Safety Recall

Mack Trucks Inc.
Greensboro, NC USA

Date	Number	Release	Page
06.2025	SC0478	01	1(6)

MMD Bench Seat Center Seat Belt Incorrect Routing MD6, MD7

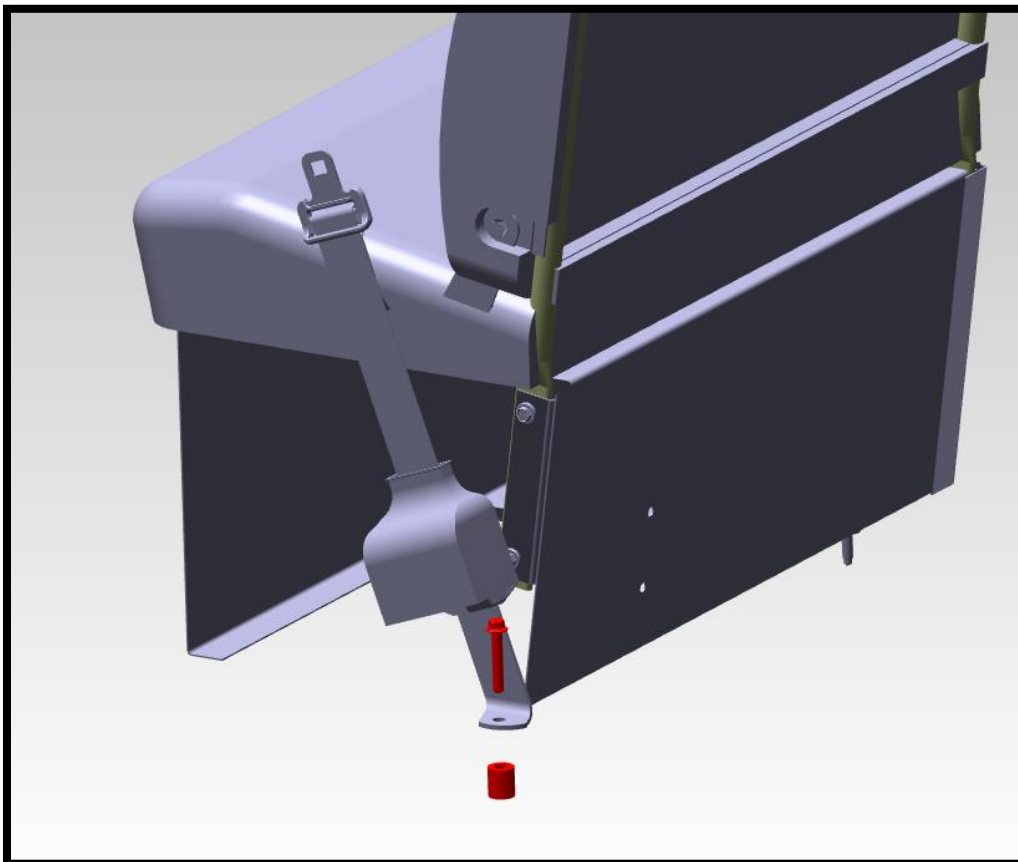
6. Locate and inspect the seatbelt for proper routing. If routing is **correct**, release truck for service. If routing is **incorrect**, proceed to step 7.

Correct routing

Incorrect routing

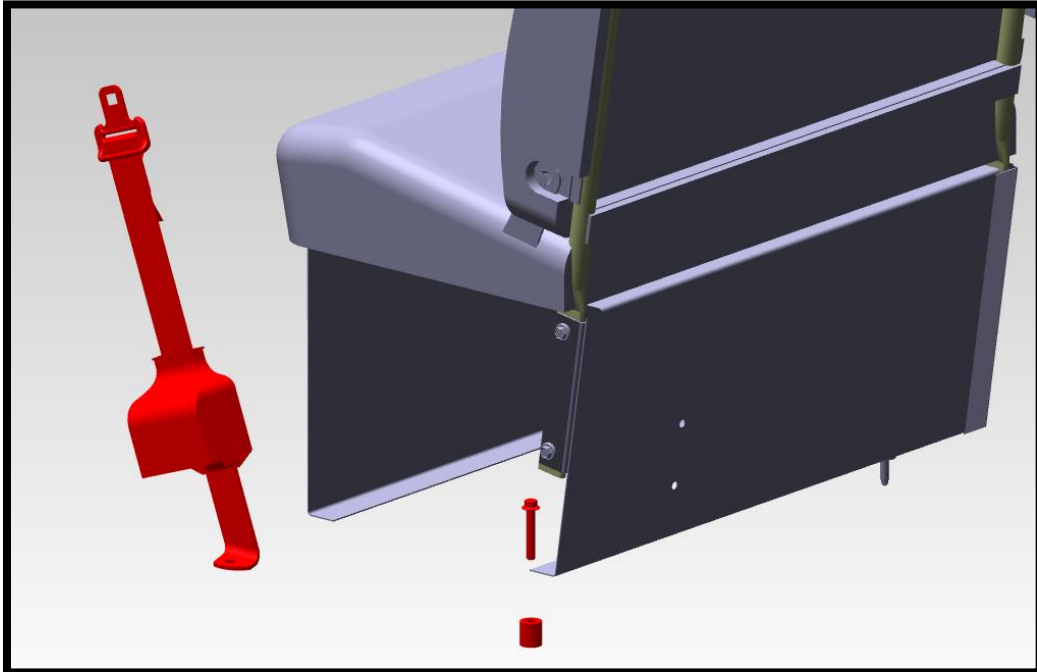
7. Remove the M10x60 flanged screw, washer, and spacer. **Discard flanged bolt only.** The spacer and washer will be reused during installation of the new seat belt assembly.

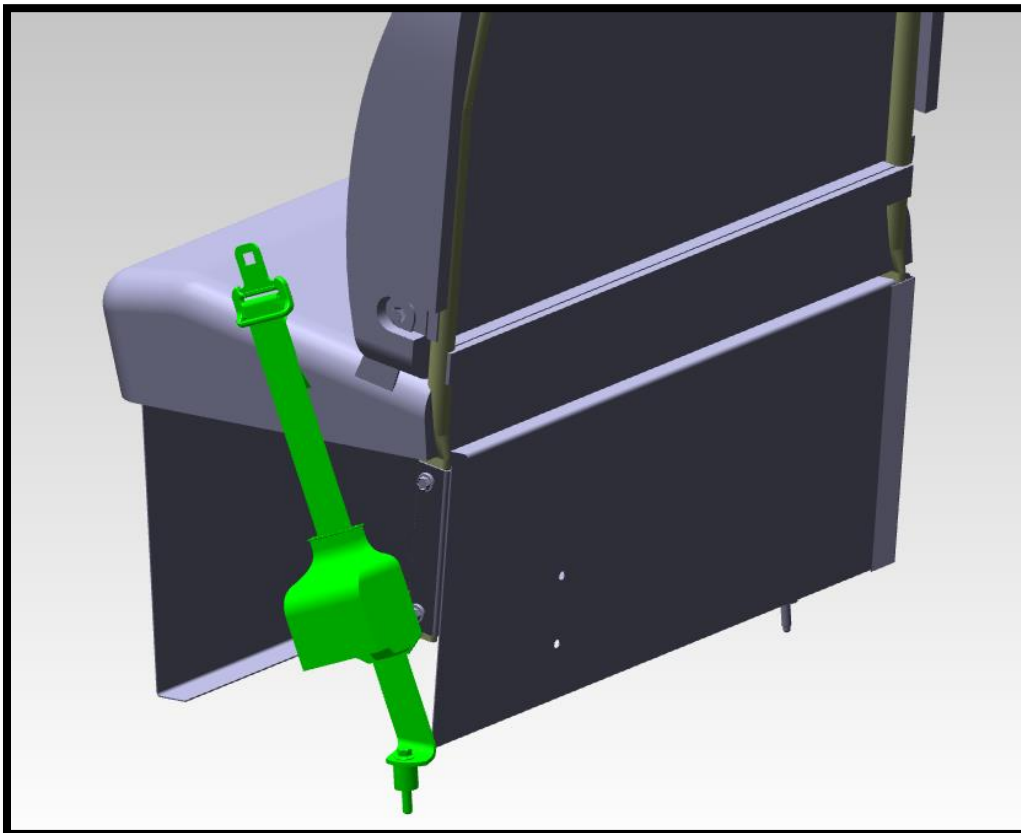
9. Install new seat belt assembly (PN: 24120542) and new M10x60 flanged screw (PN: 984757).

Flanged Screw Tightening Torque
$60 \pm 10 \text{ Nm}$ ($44 \pm 7 \text{ ft-lb}$)
